City of Portland, Maine – Building or Use Permit Application 389 Congress Street, 04101, Tel: (207) 874-8703, FAX: 874-8716

DATE: 15 MAY 98 ADDRESS: 148 Bever Ly St. (333-G-033)
REASON FOR PERMIT: To Construct a 12'x14' deck -
BUILDING OWNER: Edbridge Boyle Sr.
CONTRACTOR: Owner
PERMIT APPLICANT: ↑
USE GROUP R-3 (U) BOCA 1996 CONSTRUCTION TYPE 5B

148 Beverly St.
Portland, ME 04103

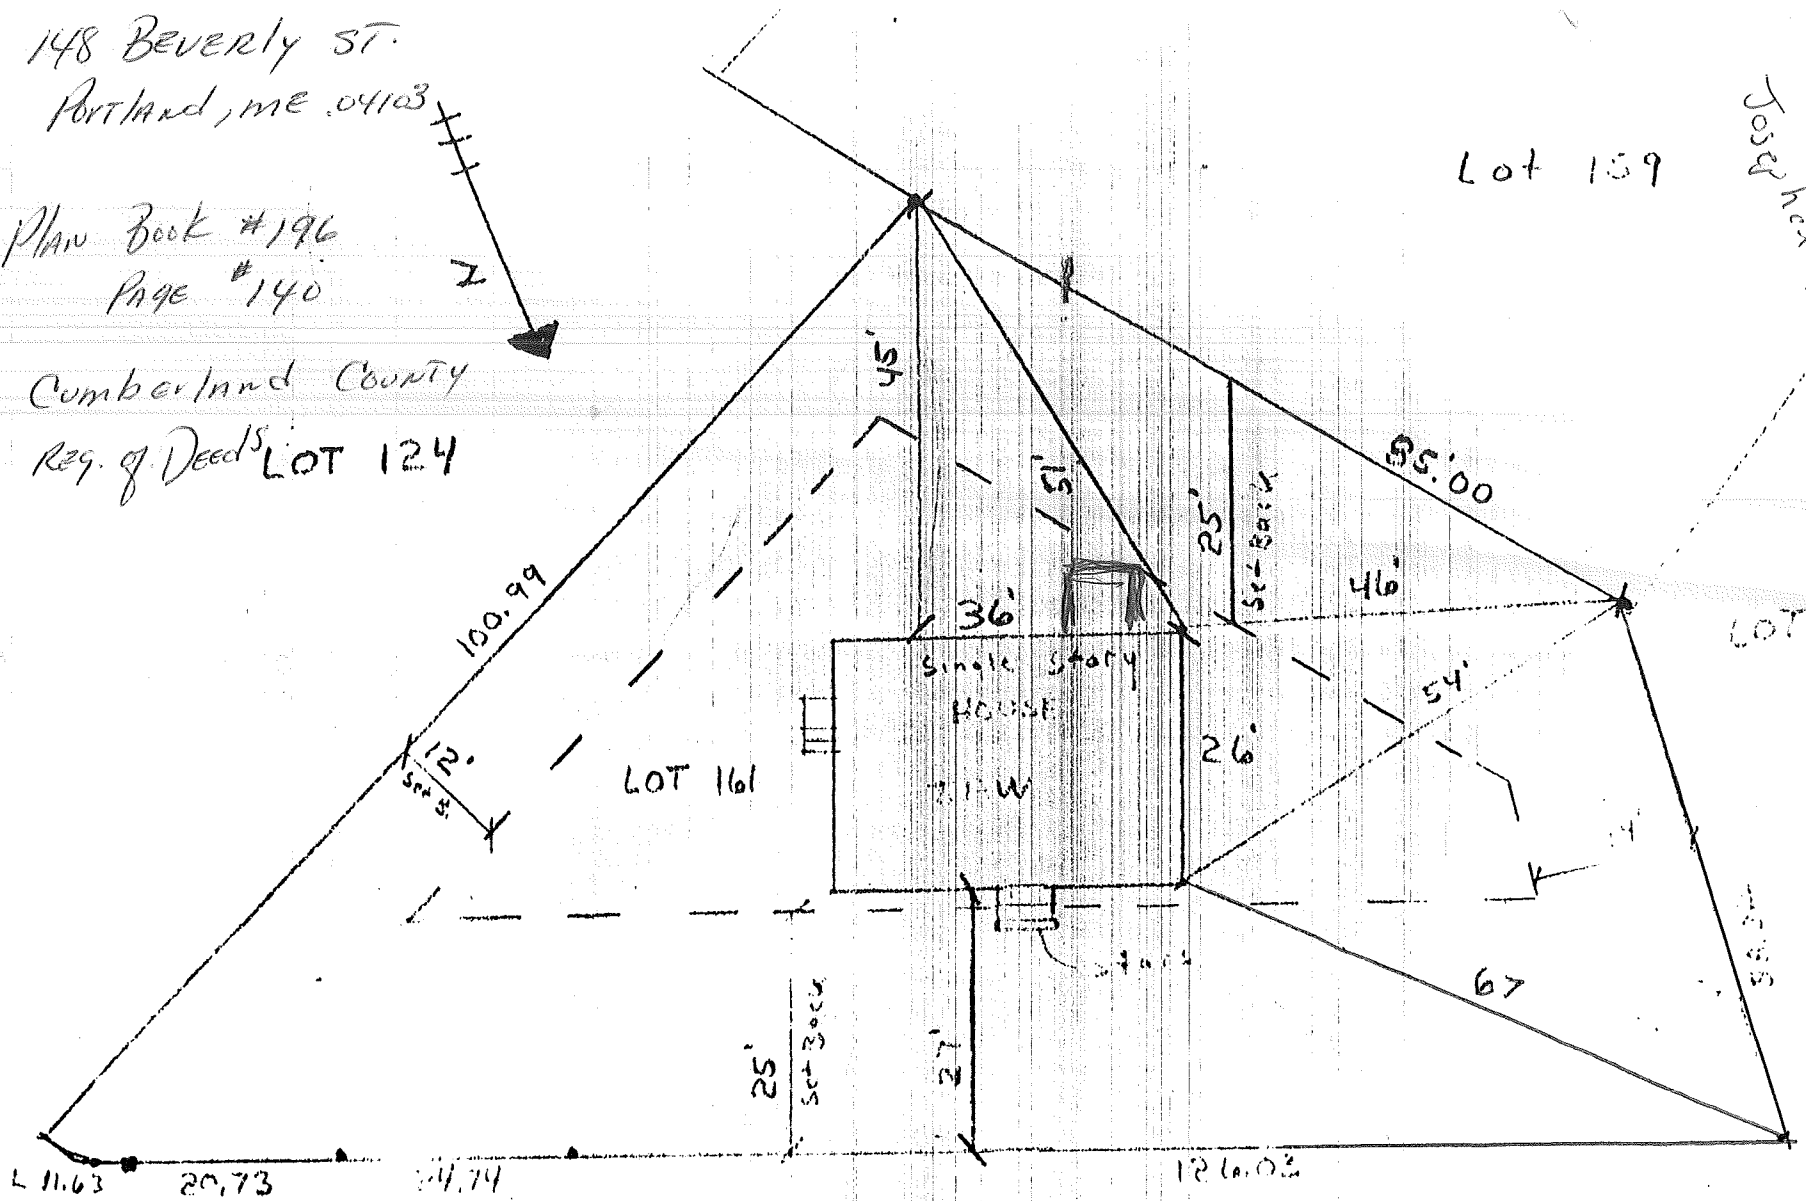
5/21/98 Attempted to Call Re: Setbacks - tel # given is fax # - will be in area today
of Stop at property

5/22/98 Met owner at Site - went over Set back Requirements (D)

8/25/99 Checked set back per requirements of 25' to rear line. All is good (JB)
Located Pins on property

- X 29. Very important - The setback (rear) from deck to lot line MUST be a minimum of 25' - This permit is void if this requirement can not be met.
30. You 10" Sono Tubes must be a minimum of 4' below grade on a footing with anchor connecting the two -
